September 18, 2019
BOARD OF COUNTY COMMISSIONERS
ORANGE COUNTY, FLORIDA
Y20-703-RC / ADDENDUM NO. 5
CONSTRUCTION OF ORANGE COUNTY FIRE STATION #87

**ORANGE COUNTY
 FIRE STATION
 87**

• sheet title
SITE DETAILS

9 SLIDING GATE ELEVATION
 3/8" = 1'-0"

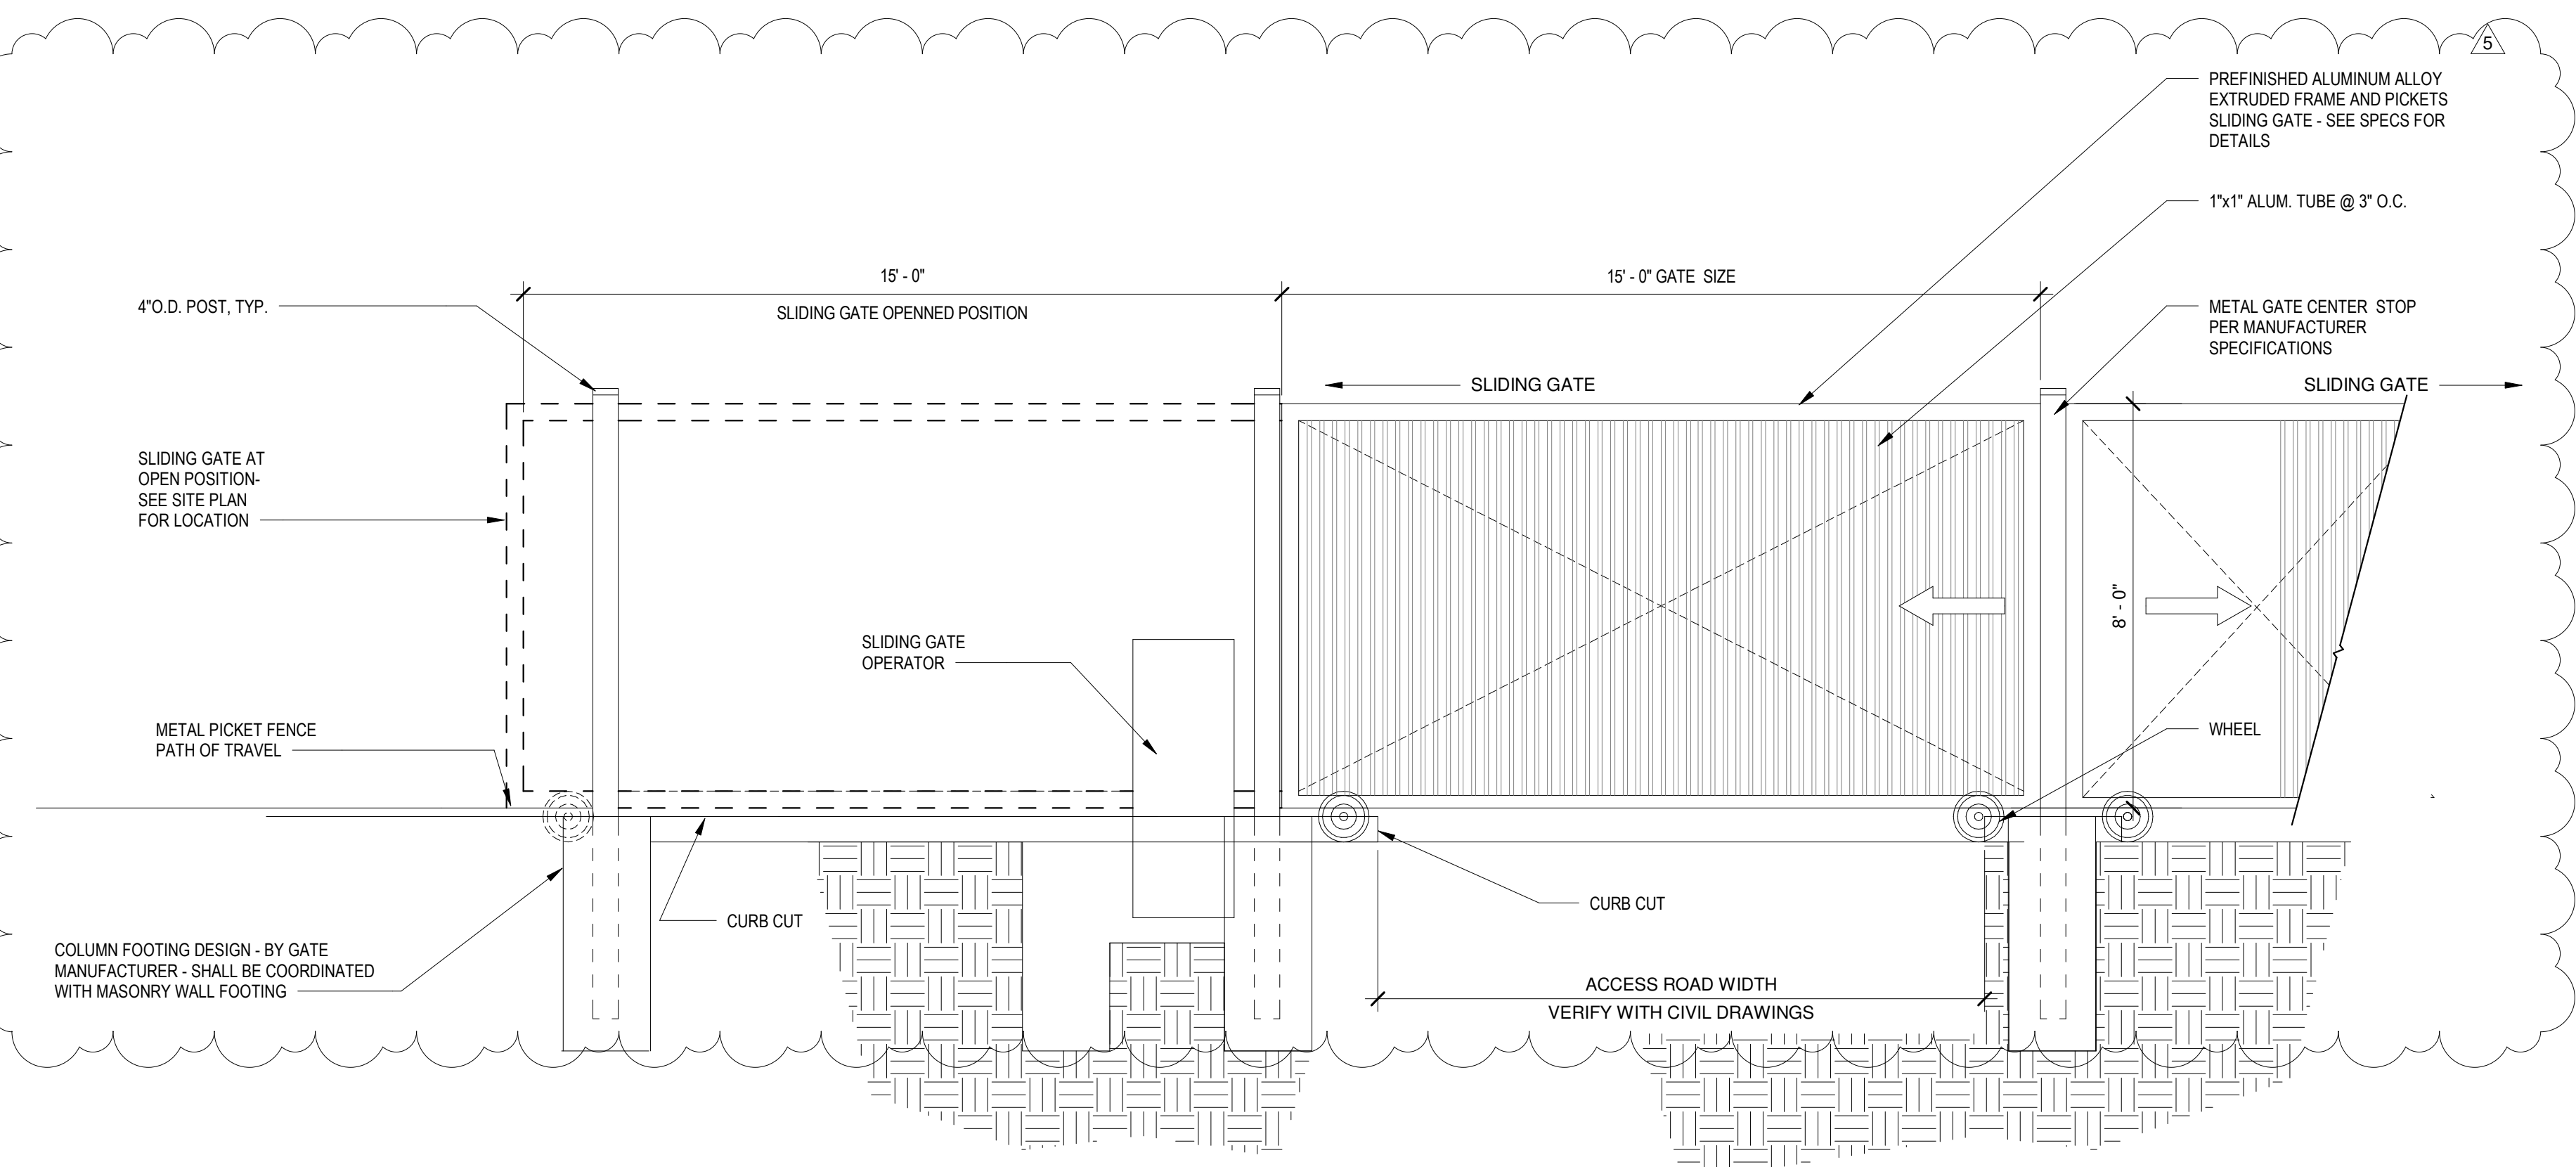
1. **Question:** For the Hysecurity gates, will they be sliding or cantilever? Please clarify. Also, for Hysecurity gate operator, will it be single speed or two speed? Please clarify.

Answer: Please see revised SECTION 323100 HEAVY DUTY SECURITY GATE WITH OPERATOR and REVISED A-011 SITE DETAILS.
